ADDENDUM NO. 2

PROJECT NAME: Snyder Building Northwest Addition
UNL PROJECT NUMBER: N095P002

DATE OF ISSUANCE: May 21, 2013
DATE OF BID OPENING: May 30, 2013

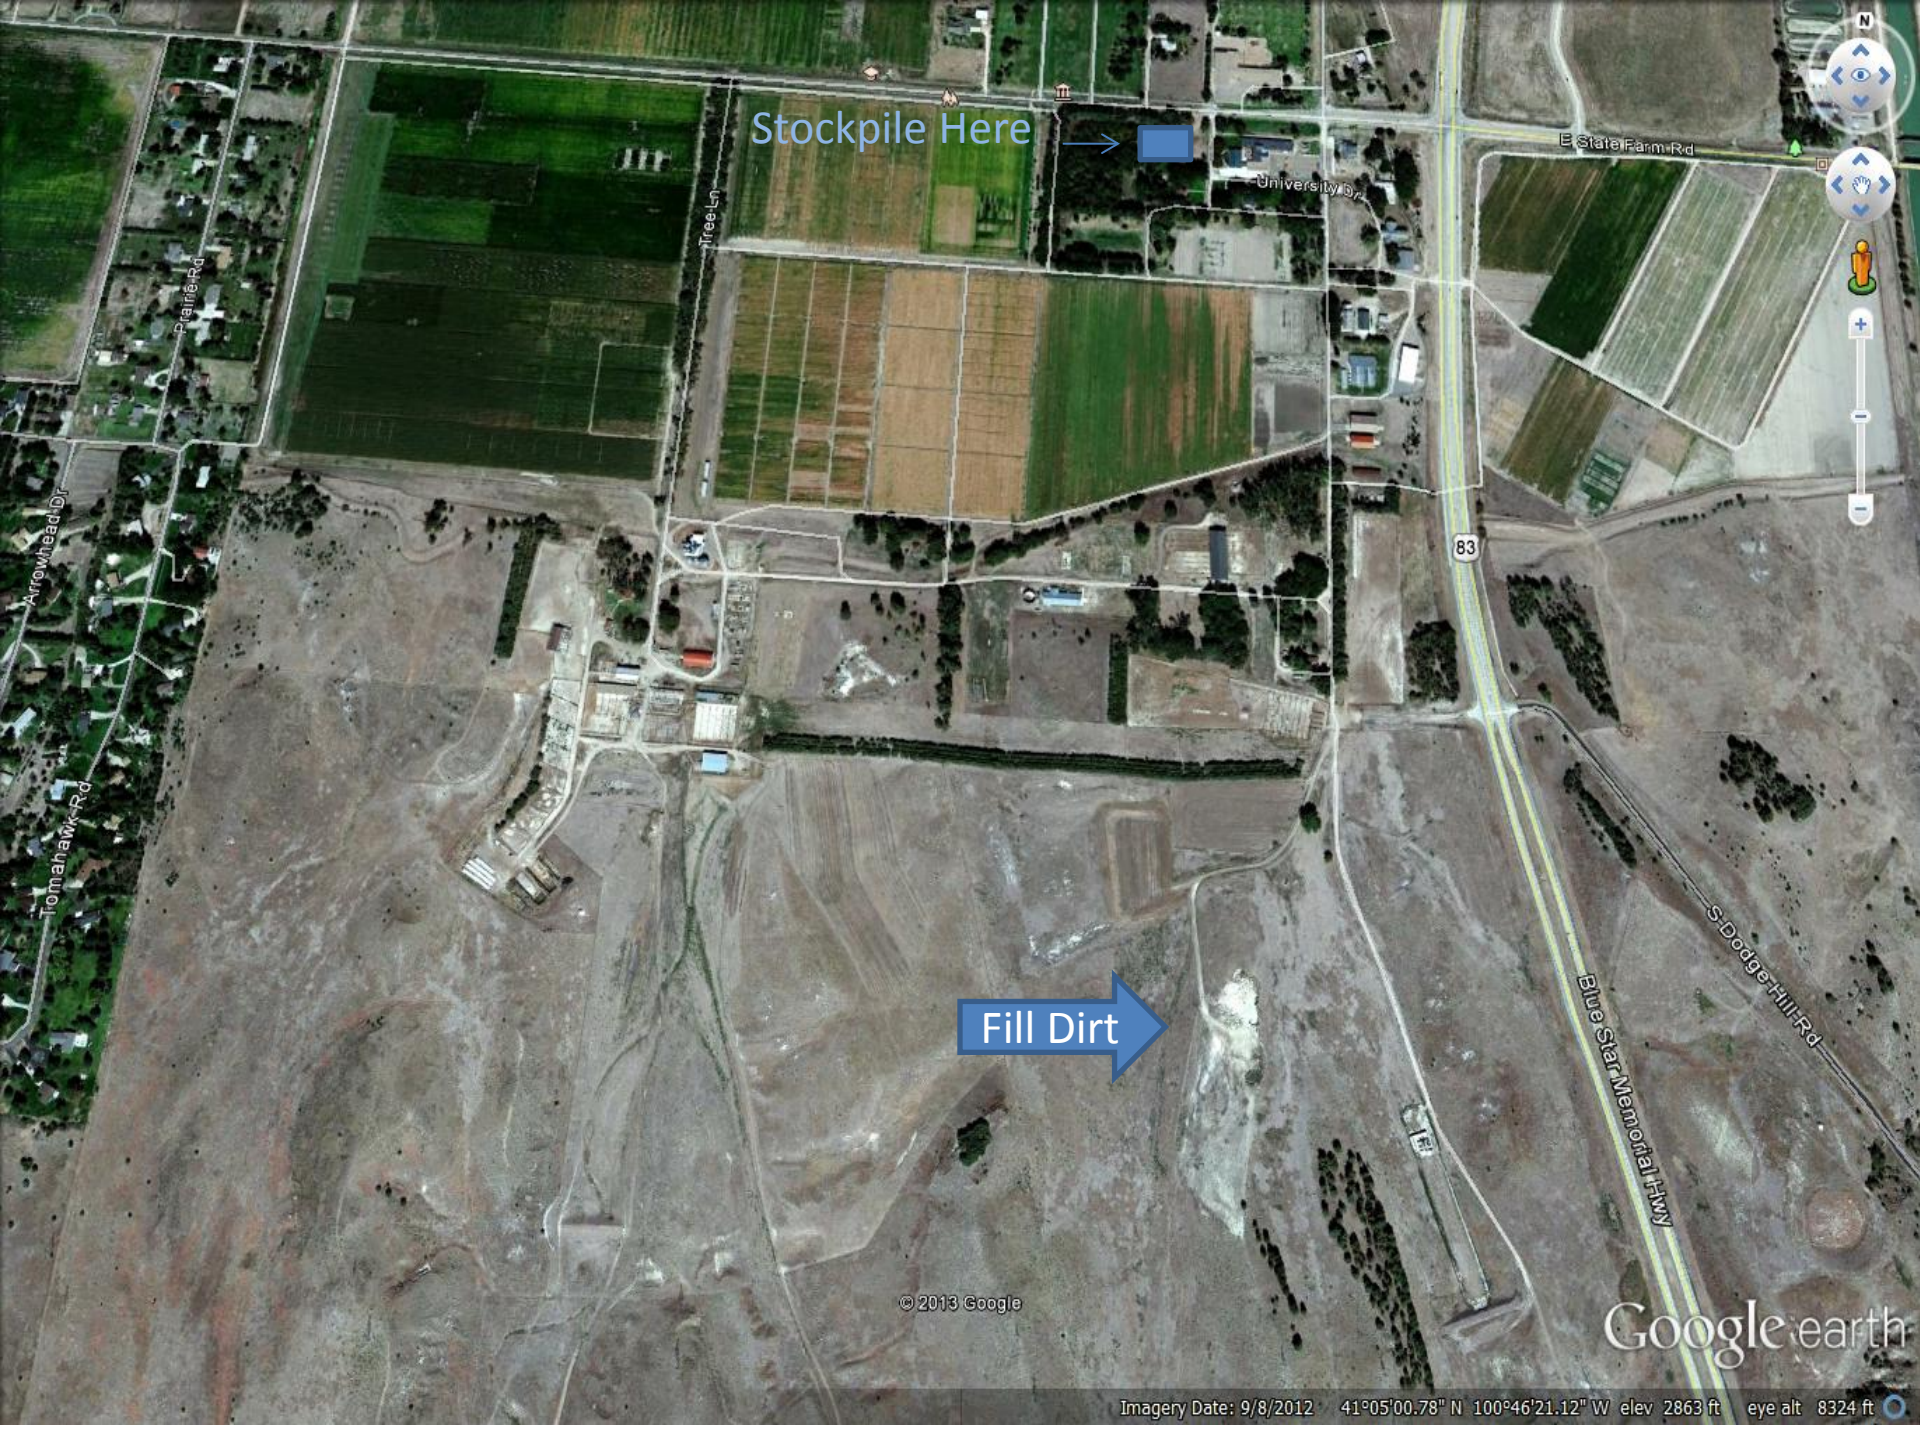
Add note 5, "Soil to be stockpiled on site. Fill soil is available from UNL. Contractor is responsible for determining fill soil is suitable for use."

See the site map provided for stockpile and fill soil locations.
